Accessibility Responsibilities Statement

Project Title: Proposed Alterations and Additions
70 The Corso, Manly

Job Number: 9019

PROJECT: Proposed Alterations and Additions

Figure 1 – Proposed Ground & First Floor
 Red highlights the subject stairway access to the First Floor area

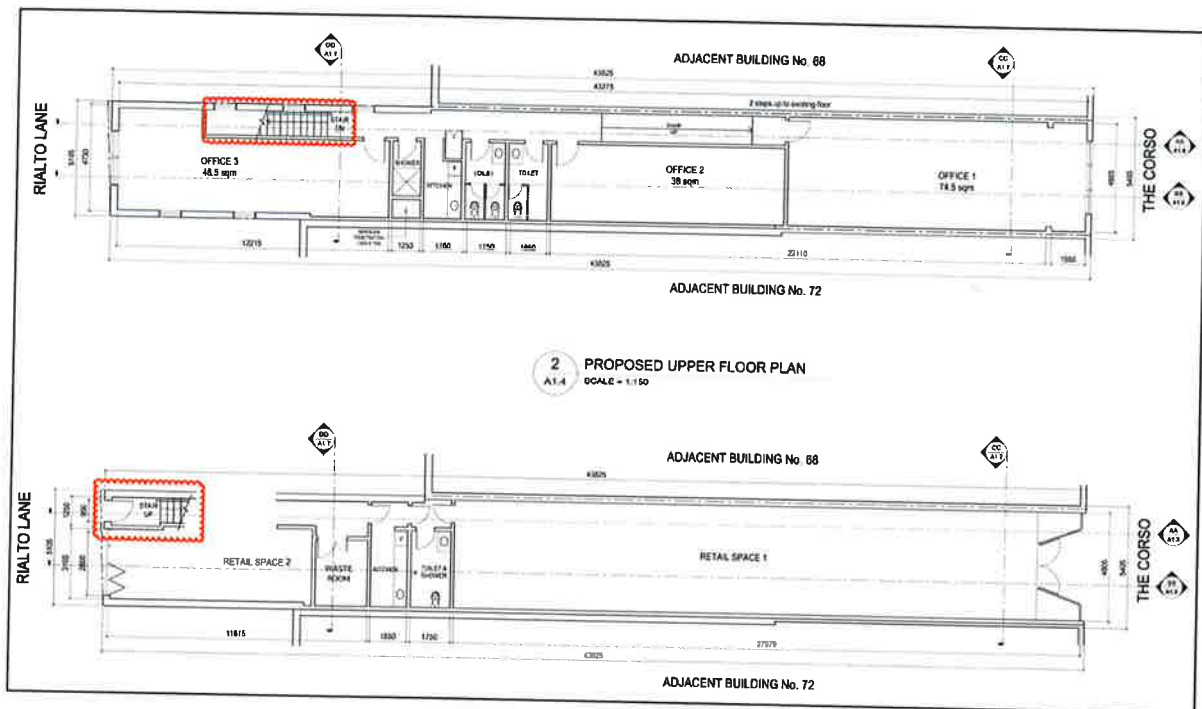
- Clause D3.1 of the BCA requires “access to be provided to and within all areas normally used by the occupants”.
- Clause D3.3 (f) (ii) of the BCA states that where a First Floor area of a 2 storey building exceeds a 200m² floor area, a ramp complying with AS1428.1-2009 or a passenger lift is required to be installed.
- The subject first floor area of the building is measured at approximately 220m², therefore requiring an accessway.
- The lettable floor space area of the first floor area is 161m².
- Stairway access will be the only means of access to the first floor area.

The above details the requirements and features of the accessway between the Ground and First floors. As such, some compliance departures have been identified by way of no accessway (via passenger lift) to the first floor area which has been requested to be addressed via a Performance Solution Report where possible.

No.	Performance Solution Scenario	DtS Provision	Performance Requirement
PS1	<p>The subject First Floor area has a 220m² floor area and is not proposed with an accessway via passenger lift/ ramp.</p> <p>The Performance Solution will be based on the fact there is a 161m² of lettable floor space area for a direct comparison of DtS provision D3.3 (f) (ii).</p> <p>This Performance Solution is subject to –</p> <ul style="list-style-type: none"> The internal stairway achieving compliance with AS1428.1-2009. A lettable floor space area of less than 200m². 	Cl. D3.1 & D3.3(f) (ii)	DP1
